REPORT TO WHITESTONE MUNICIPAL COUNCIL

RE: Response to Oct 7, 2022 report submitted to Council by John Jackson, Planner, "Draft Plan of Subdivision, STO Networks" (Keene subdivision)

Submitted by: Lake Wah-Wash-Kesh Conservation Association (WWKCA), Planning and Development Committee (PAD)

Date: October 17, 2022

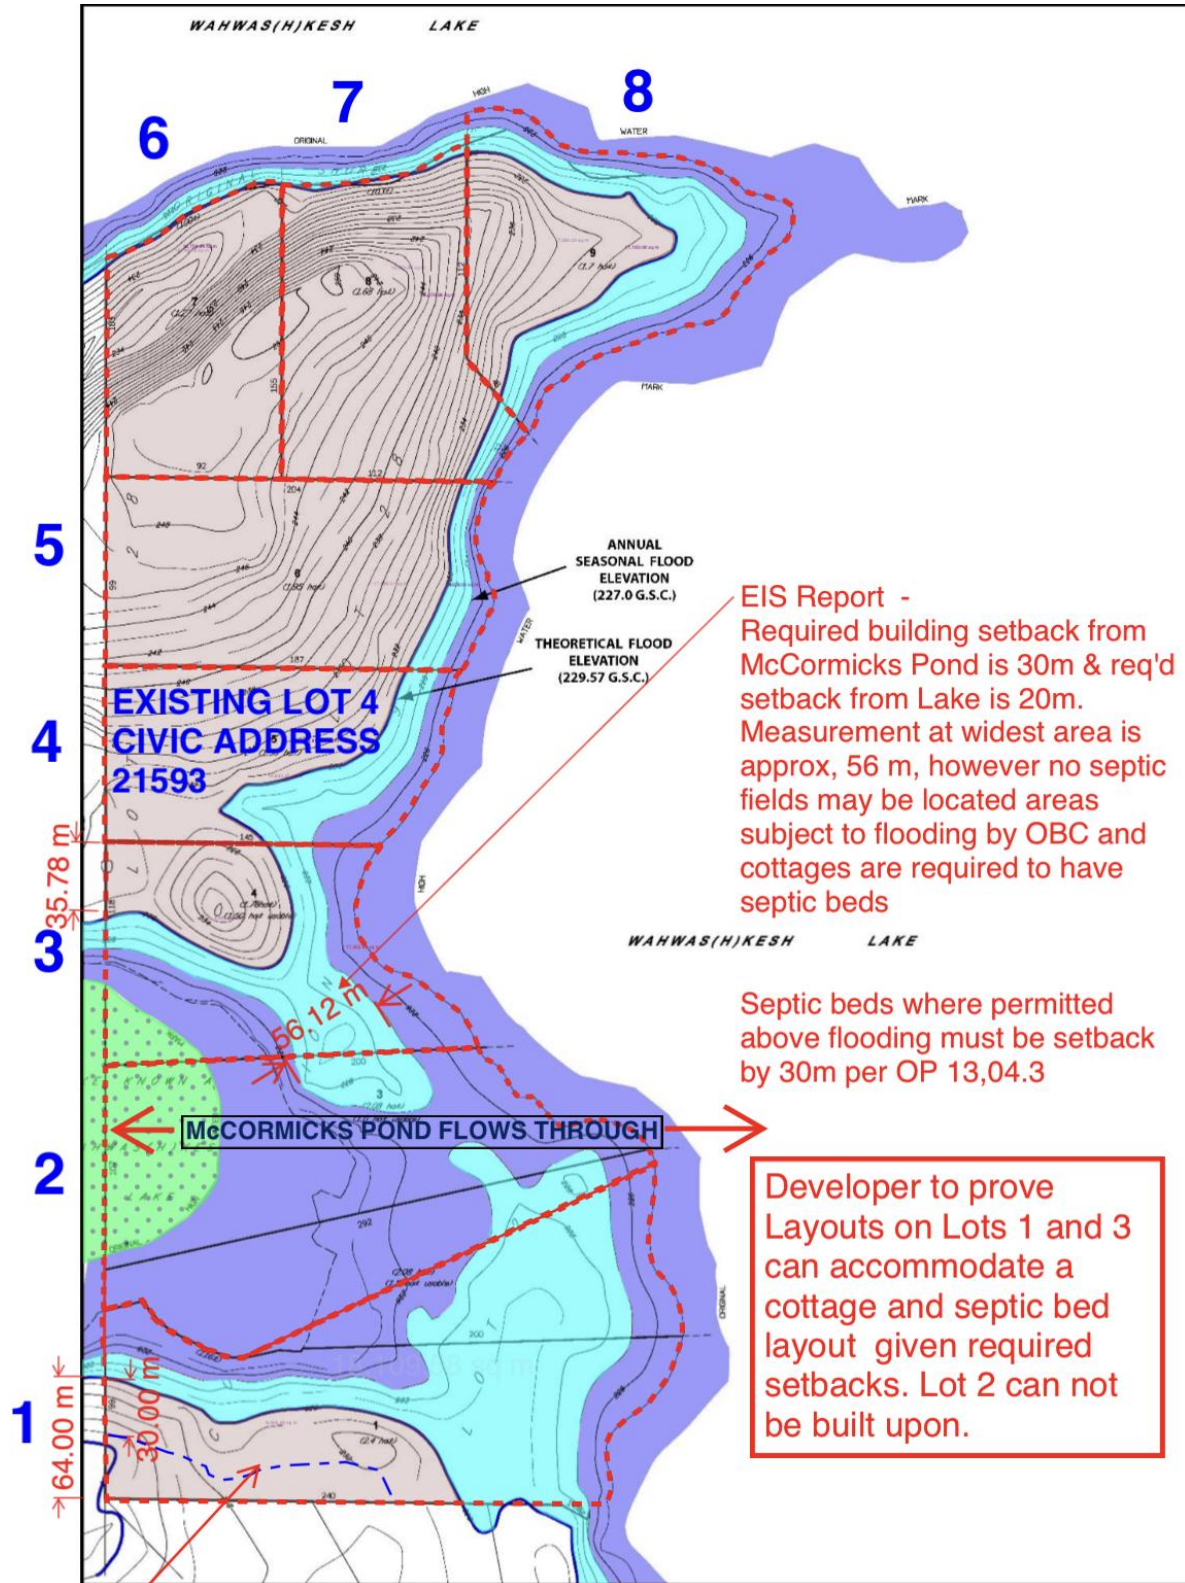
Pictured below is a coloured version of the “subdivision redline” included with the Planner’s report dated October 7, 2022. Flooding occurs across the proposed Keene subdivision over proposed Lots 1, 2, 3 and into 4. The flooding of environmentally sensitive McCormicks Pond, including the Type 1 Fish Habitat, is likely to impact fish habitat, contrary to Section 12.01.1 of the OP which states that “new development will only be permitted where it can be carried out without negative impact on fish habitat.” The Report does not deal with this issue.

EIS Report -
 Required building setback from McCormicks Pond is 30m & req'd setback from Lake is 20m. Measurement at widest area is approx, 56 m, however no septic fields may be located areas subject to flooding by OBC and cottages are required to have septic beds

Septic beds where permitted above flooding must be setback by 30m per OP 13,04.3

Developer to prove Layouts on Lots 1 and 3 can accommodate a cottage and septic bed layout given required setbacks. Lot 2 can not be built upon.

← 30m setback line for built structures and septic beds

As can be seen by the picture above, lots 1, 2, and 3 are impacted by flooding from McCormicks Pond. **Lots 2 and 3 should be eliminated because of flooding and because of required setbacks from the environmentally sensitive McCormicks pond and lack of area for an approved septic.**

Further, WahWashKesh is the only lake in OP mentioned under 12.05 Hazard Lands for its unique extreme flooding that can occur anytime throughout the season. The Planner refers to the “summer static dam height” and the outline on the newly submitted “Subdivision redline” picture (note this is not a proper survey) leads the reader to believe that spring is the only time septic beds will flood. This is not true.
